TVA-BFN-TS-416

BROWNS FERRY NUCLEAR PLANT (BFN) - UNIT 3 - TECHNICAL SPECIFICATIONS (TS) CHANGE 416 - REVISED SAFETY LIMIT MINIMUM CRITICAL POWER RATIO (SLMCPR) (TAC NO. MB0436)

PROPOSED TECHNICAL SPECIFICATIONS (TS) CHANGE TS-416 DESCRIPTION AND EVALUATION OF THE PROPOSED CHANGE

Figure 2 Reference Core Loading Pattern – Cycle 11

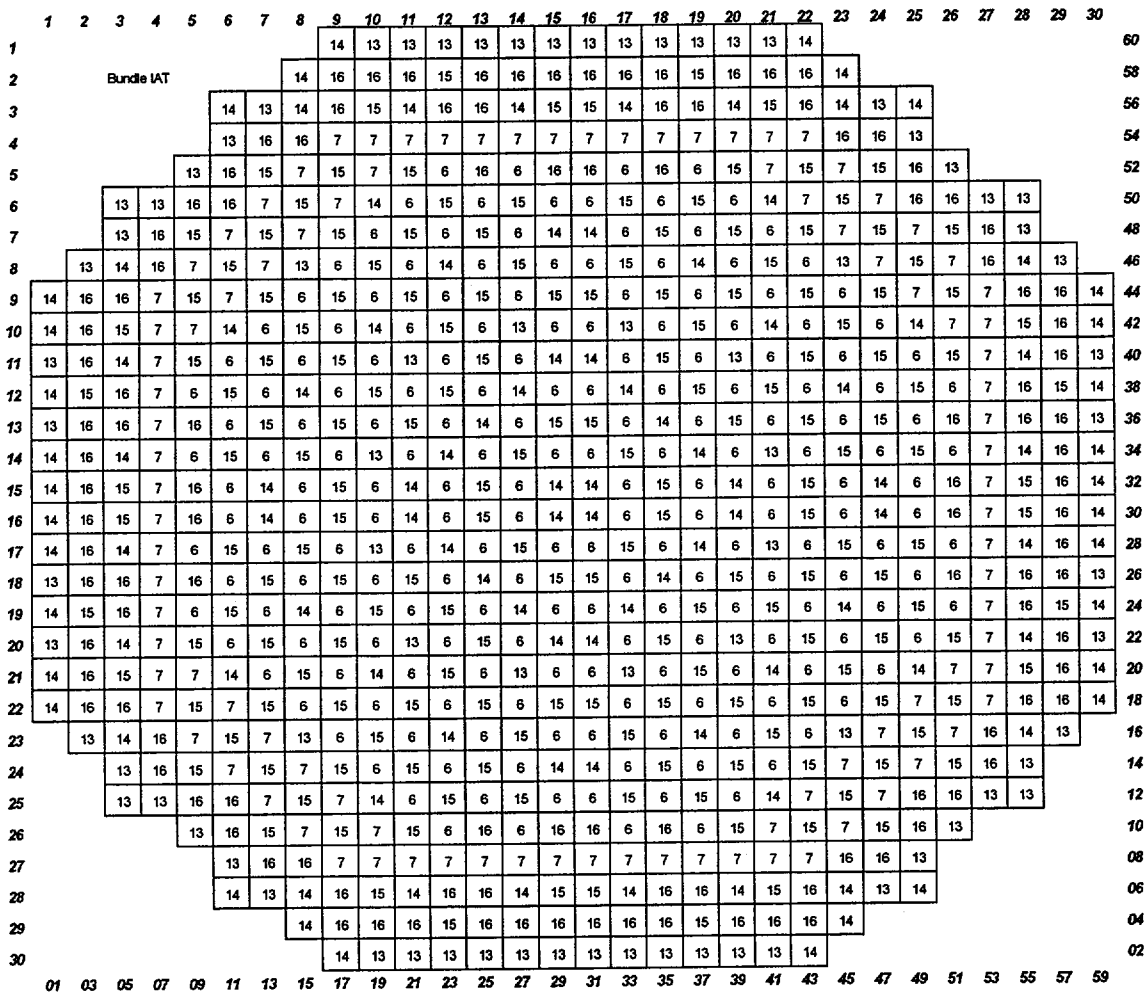
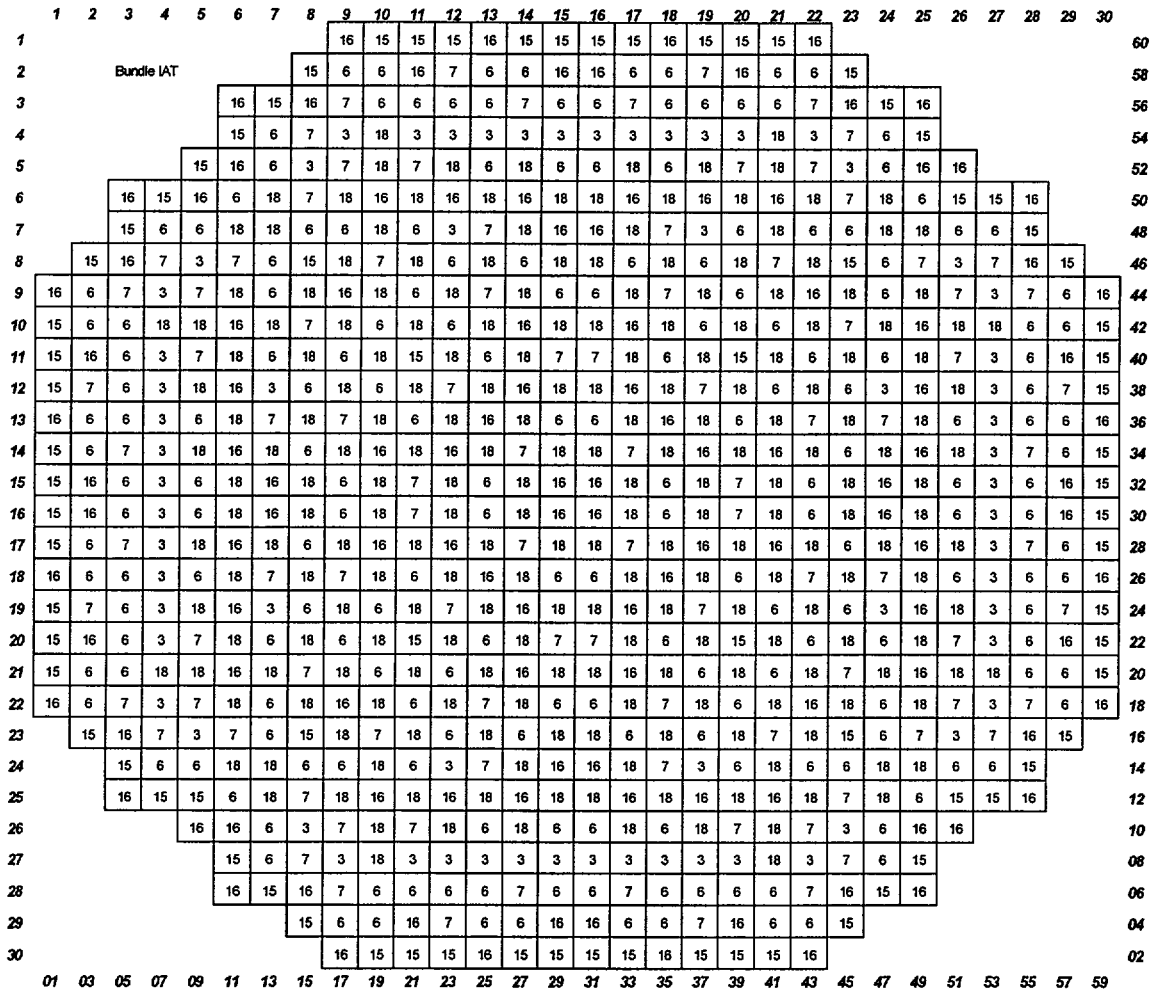
The core loading information for Browns Ferry Unit 3 Cycle 10 and 11 is provided in Figures 1 and 2, respectively. The impact of the fuel loading pattern differences on the calculated SLMCPR is correlated to the values of [[]] The power and non-power distribution uncertainties that are used in the analyses are indicated in Table 1.
